Process Sheet

Customer	: CC-DAR01 Dart Aerospace Ltd.	Drawing Name	: REWORK
Job Number	: 39663		
Estimate Number	: 10804		
P.O. Number	:	Part Number	: D3276041
This Issue	: 03/06/2008 S.O. No. :	Drawing Number	: NCR08-053
Prsht Rev.	: NC	Project Number	:
First Issue	: // Type : SMALL /MED FAB	Drawing Revision	:
Previous Run	: 39662	Material	:
Written By	: 	Due Date	: 10/06/2008 Qty: 1 Um: Each
Checked & Approved By	:		
Comment	:

From: David Shepherd [dshepherd@dartaero.com]
Sent: June 26, 2008 1:08 PM
To: 'Chris Provencal'
Cc: 'Mike Petsche'
Subject: RE: NCR D3276-041

WORK ORDER NON-CONFORMANCE (NCR)

D3276-041 BAFFLE ASSEMBLY, LH (SHOWN) D3276-042 BAFFLE ASSEMBLY, RH (BEND/JOGGLE OPPOSITE)

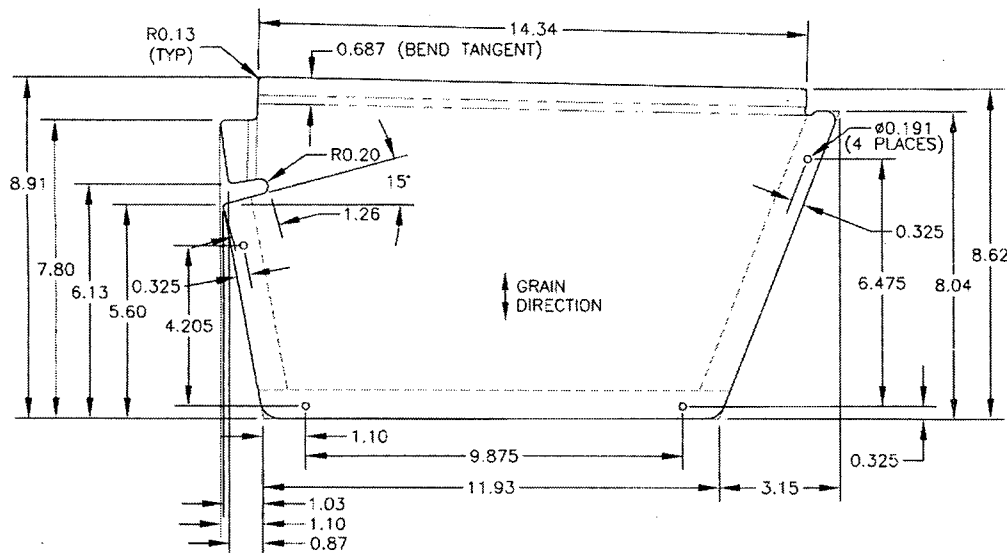
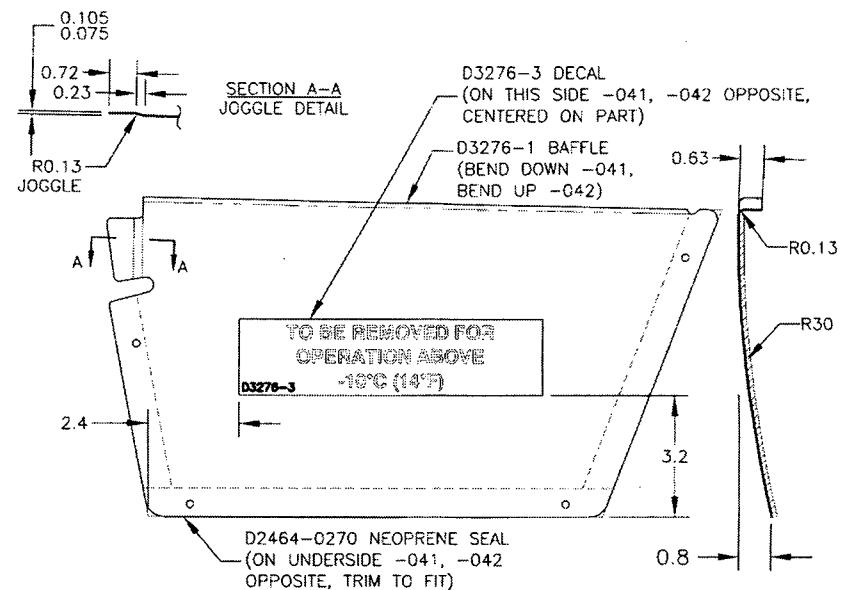
Since they were re-bent after powder, could you do an LPI to check for cracks rather than a powder removal. If the metal is cracked, the paint will also be cracked, right? If not, perhaps you could spot check a couple for cracks?

Do we need to clarify the drawing to prevent this from happening again and to change to the 45 degrees for the future? I believe the 45 degrees was covered on a deviation.

Again, though, why is it 22? And why is it only discovered after paint? Its like we need to bend 1 and then check that we are bending it right before we bend the rest.

Qty(22) D3276-041 Baffle Assembly. The joggled tab was bent in the opposite direction from the dwg. They were all reworked to the correct the joggle (re-bent opposite). The grain directions are all at 45 degrees (not vertical per dwg). They were bent while powder coated, so it's impossible to inspect the surface of the aluminum in their current state. One baffle cracked during re-bending.

The part is bolted in, the tab is unlikely to be under any significant stress. However, I'm thinking they should maybe strip the parts (at least locally) to inspect the surface for cracks, especially since one cracked during re-bending. That probably won't be popular....

The re-work is not in an obviously non-structural location so I don't have delegation to approve the parts. What do you think?

I would be inclined to accept these parts. As you mention, they will not be under any load. Also, if the tab breaks off, I have checked with Harvey, and it will fall into an area of the R44 helicopter where it will not cause any damage.
